Access Compliance Report

Public Rights-of-Way

(Curb Ramps)

Intersection ID: 3871	Main Street: FOXBRIAR_TL	Cross Street: IVY_RIDGE_PL	Location:	N
ADA ID: 356BAFC884D3	Ramp Type: Perp	Initial Pass/Fail: Fail	Overall Compliance: No	Severity Score: 10

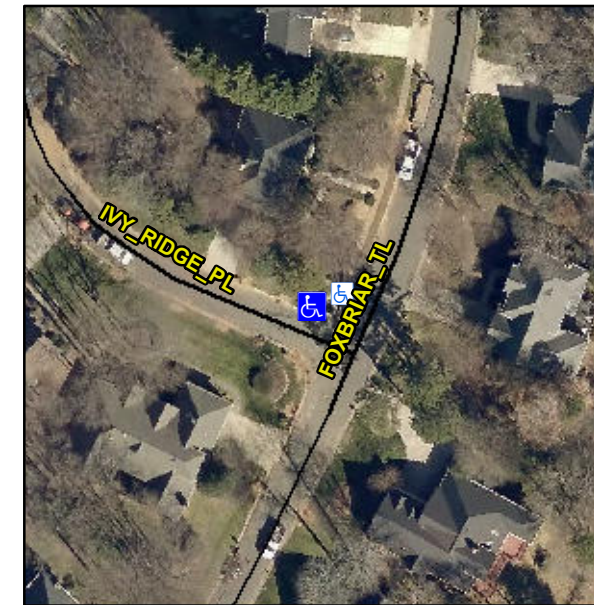
Not Found, R304.5.1, R304.5.3

Compliance	Description	Data	Compliance	Description	Data
N/A	Ramp Length (in)	42.0	Yes	Ramp Slope (%)	8.2
No	Ramp Width (in)	46.0	No	Ramp XSlope (%)	3.5
N/A	Flare Type LT	N/A	N/A	Flare Type RT	N/A
N/A	Flare Slope LT (%)	N/A	N/A	Flare Slope RT (%)	N/A
N/A	Flare Traversable LT?	N/A	N/A	Flare Traversable RT?	N/A
N/A	Landing Length (in)	N/A	N/A	DWS Provided?	N/A
N/A	Landing Width (in)	N/A	N/A	DWS Contrast?	N/A
N/A	Landing Slope (%)	N/A	N/A	DWS Length (in)	N/A
N/A	Landing X Slope (%)	N/A	N/A	DWS Full Width?	N/A
N/A	Landing Curb? (Y/N)	N/A	N/A	DWS Offset (in)	N/A
N/A	Shared Landing?	N/A			
N/A	Gutter Ponding?	N/A	N/A	Gutter Slope (%)	N/A
N/A	Gutter Lip Ht (in)	N/A	N/A	Gutter X Slope (%)	N/A
N/A	Painted X Walk1?	No	N/A	Painted X Walk2?	N/A
	X Walk 1 Direction	To SW		X Walk 2 Direction	N/A
N/A	X Walk 1 Width (in)	N/A	N/A	X Walk 2 Width (in)	N/A
	X Walk 1 Slope (%)	2.1		X Walk 2 Slope (%)	N/A
	X Walk 1 X Slope (%)	6.5		X Walk 2 X Slope (%)	N/A

Remove & Replace Entire Ramp.
